Provo School District

Construction Update

May 28, 2024

Proposed Changes for the Master Plan

5 – Windows & Mechanical Louvers

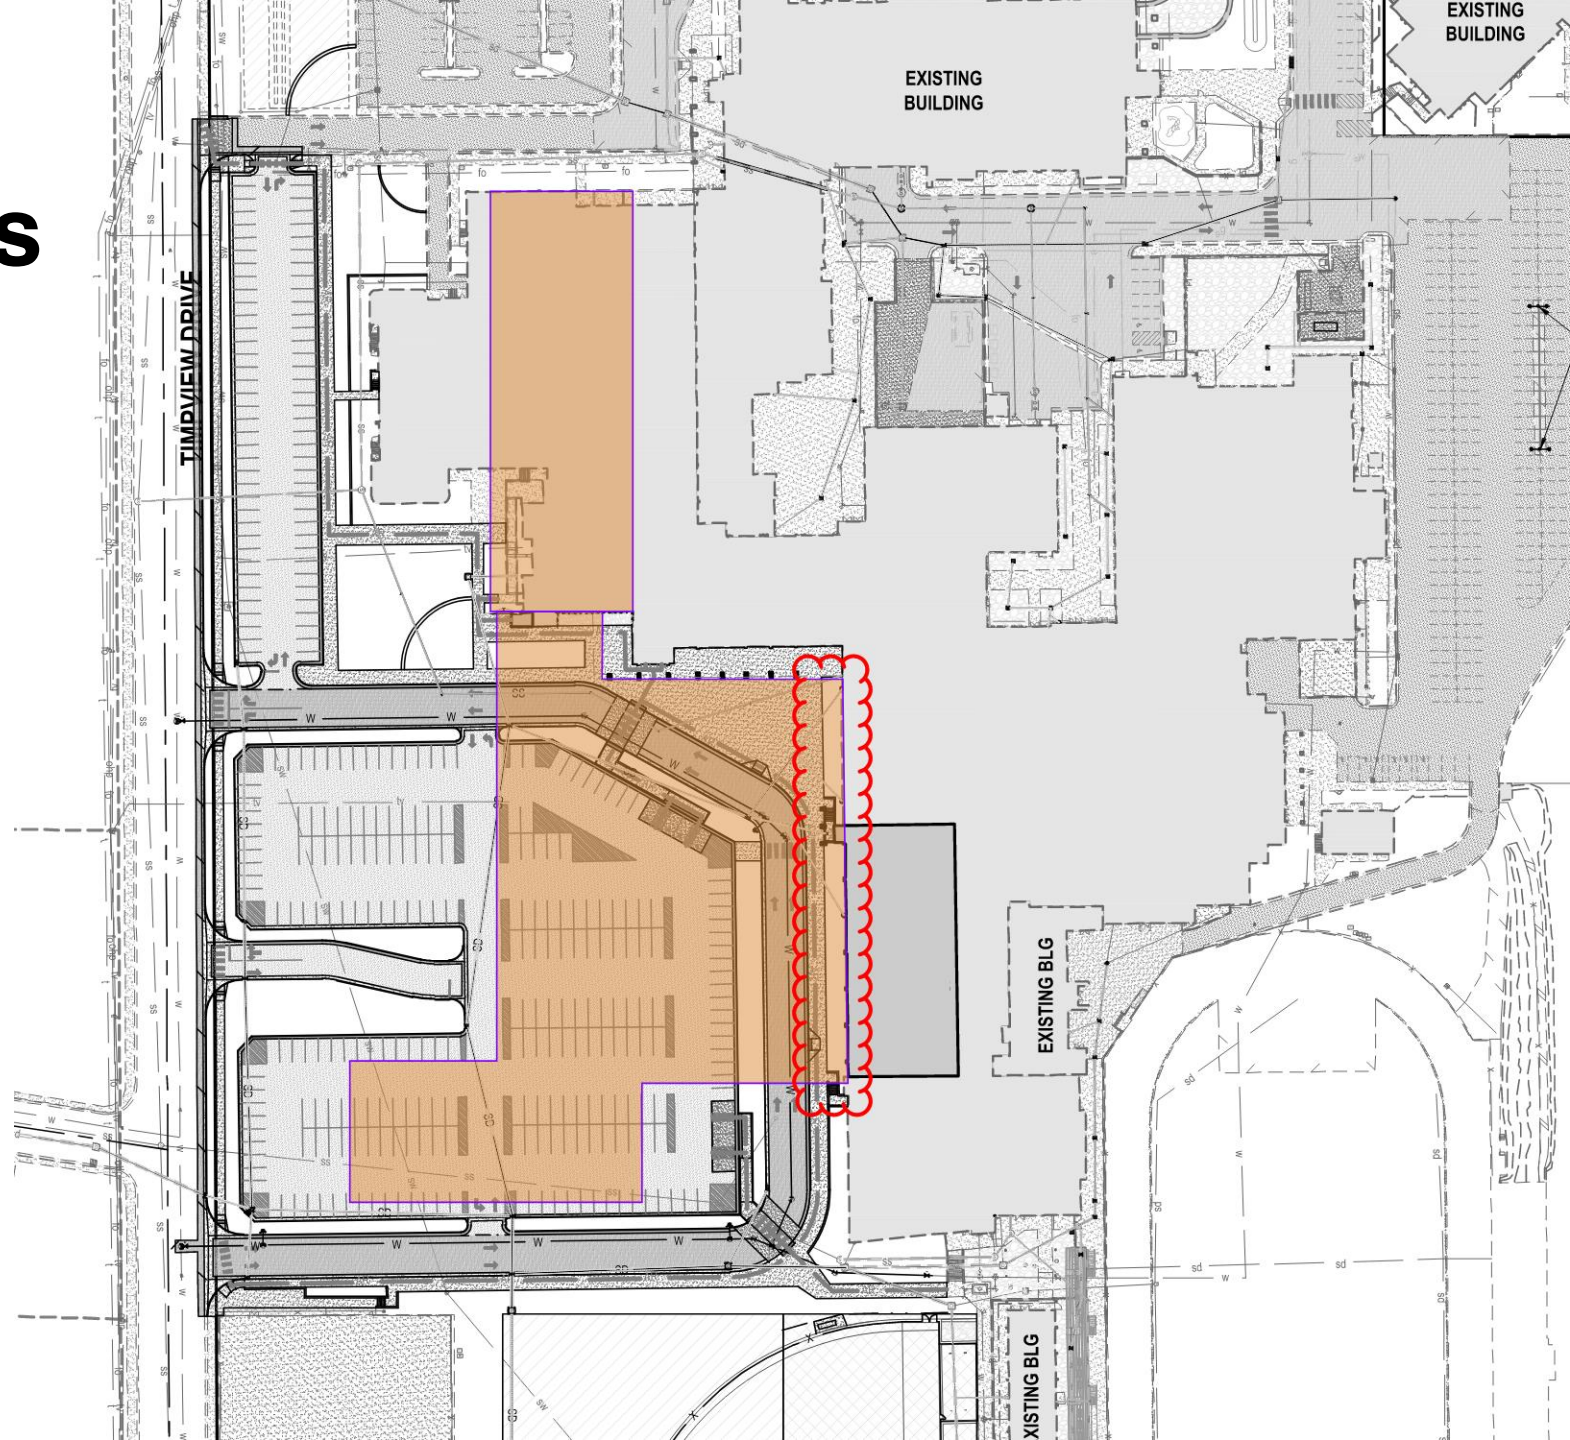
The addition is planned to be directly against the west and south elevation of the current phase which would block windows and louvers.

- Eliminate side vented mechanical louvers and replace with rooftop exhaust.
- Eliminate windows and provide skylights (see following sheets for impacts)

- Eliminate louvers & windows in red.
- Replace openings with masonry.
- Provide rooftop exhaust and skylights in green.

6 – Masonry Walls

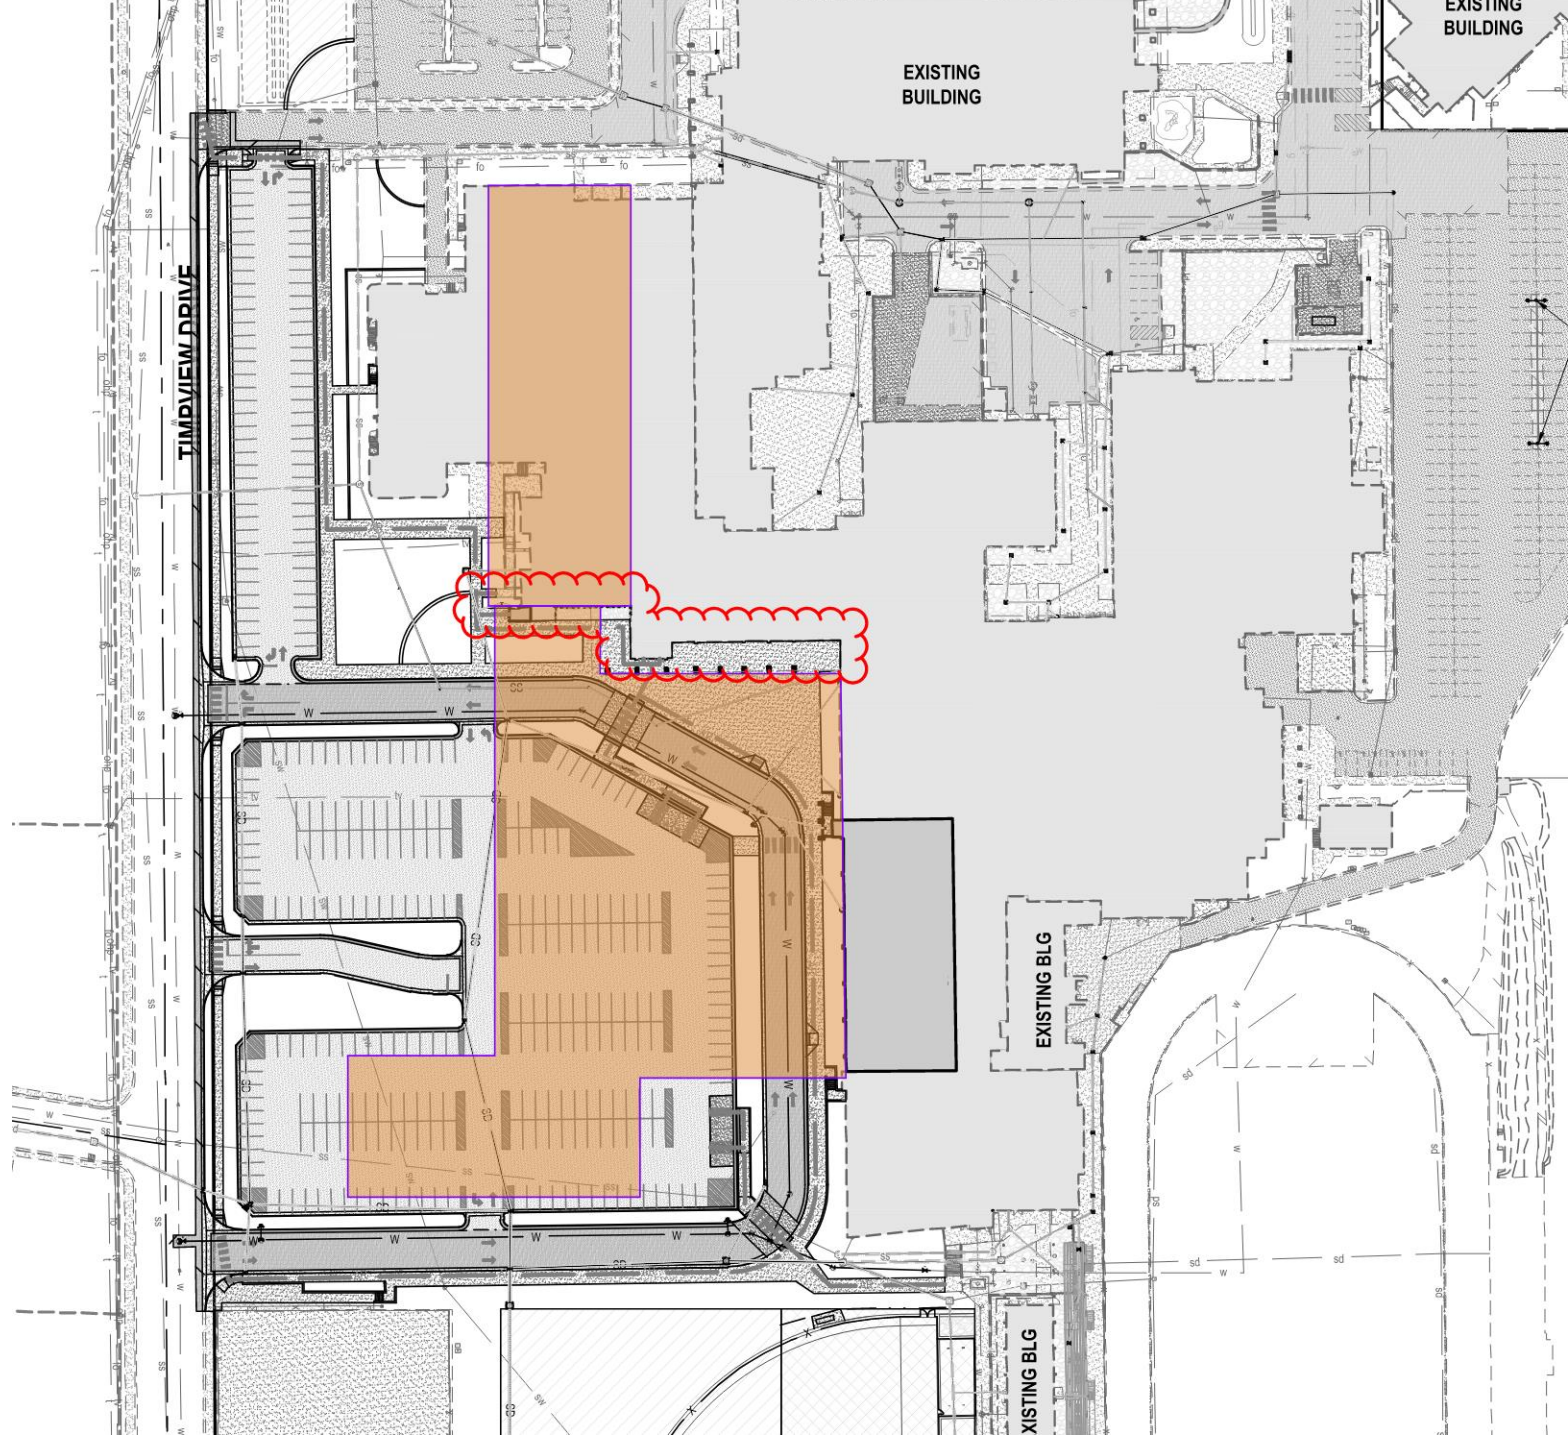
Current plans have decorative brick walls in locations that will require demolition or will be covered by the proposed addition.

- Leave existing brick in place at administration and paint.
- Eliminate decorative brick at main entry and replace with a standard painted brick.

7 – Cafeteria

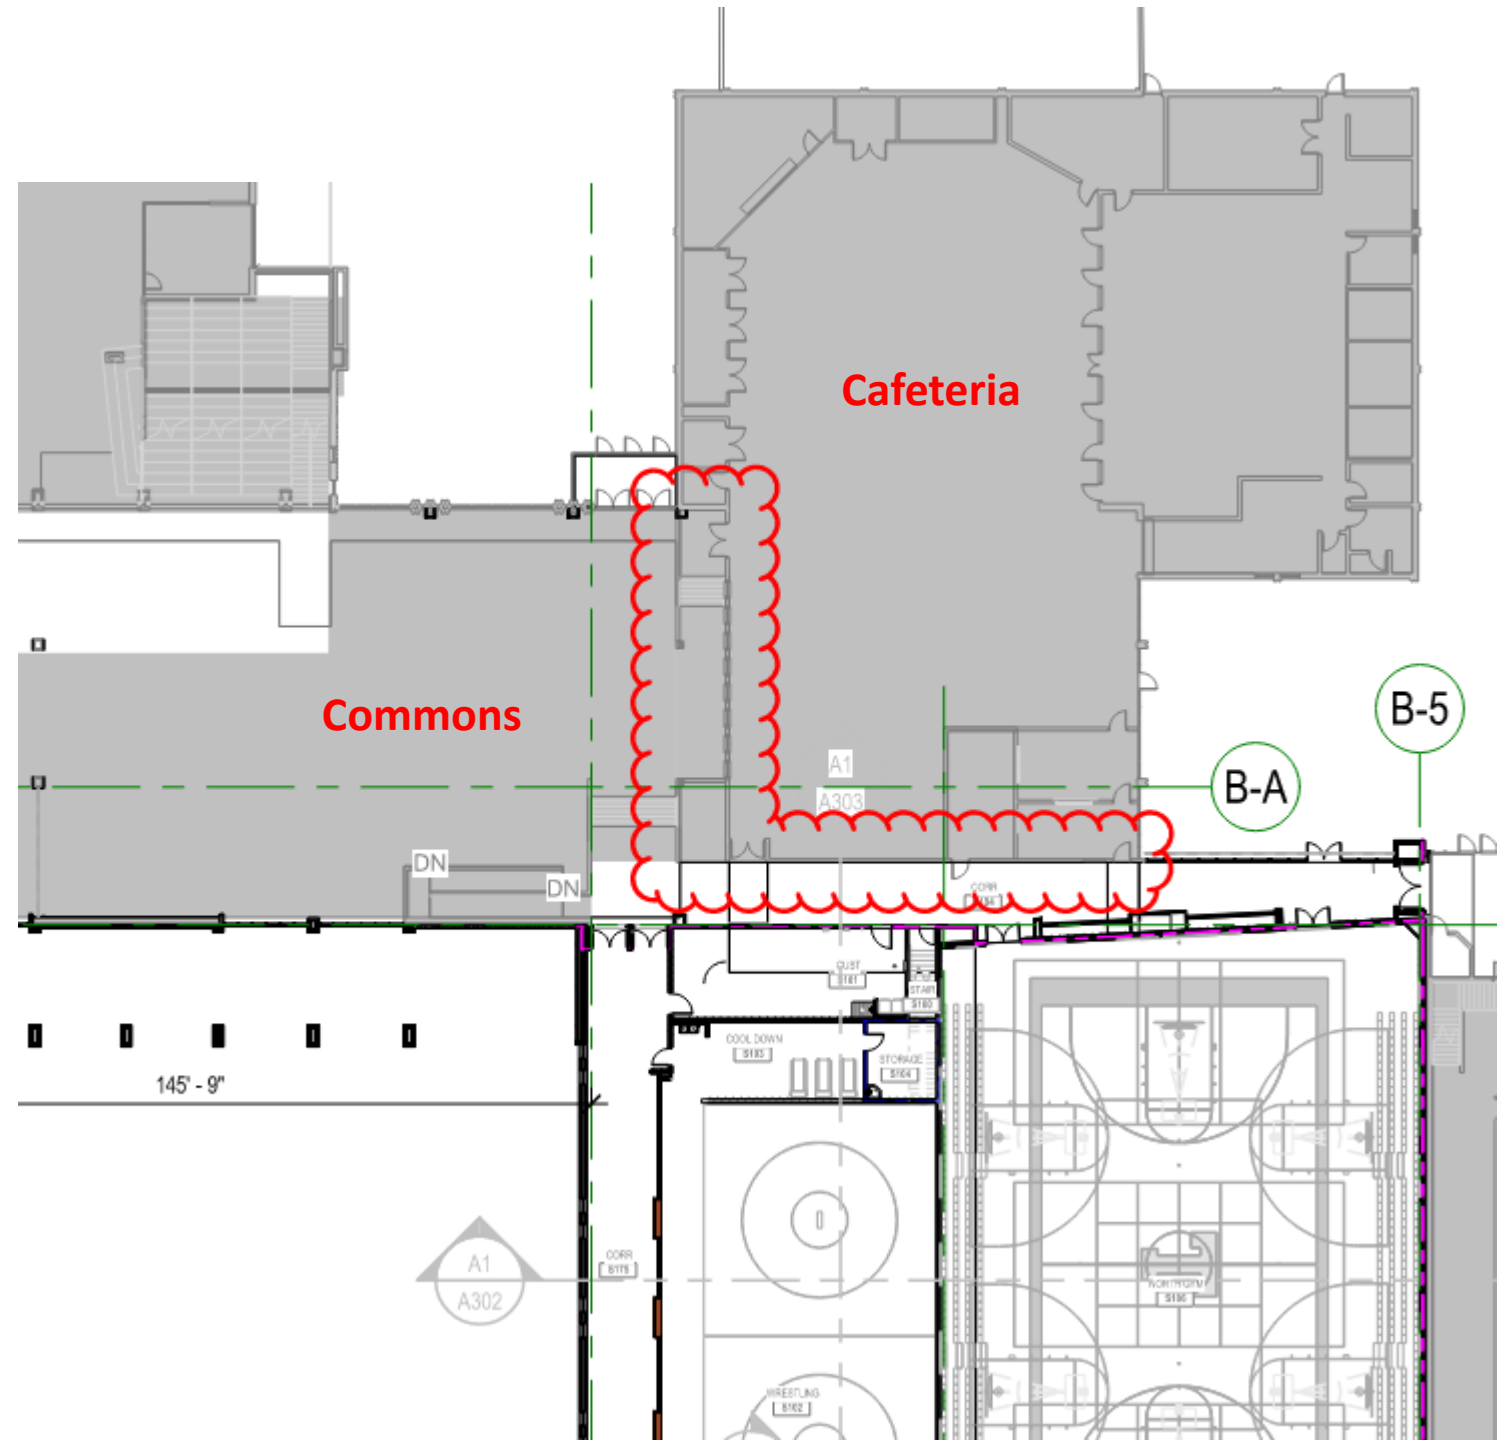
With the intention of creating a more open cafeteria into the corridor and commons, these walls are planned to be demolished during the cafeteria remodel.

- Demolish the south wall now while exposed and replace with permanent structural support and a temporary wall until the remodel is complete.
- Modify finishes, transitions and the ADA ramp from the Commons to the Cafeteria to match the remodel plans.
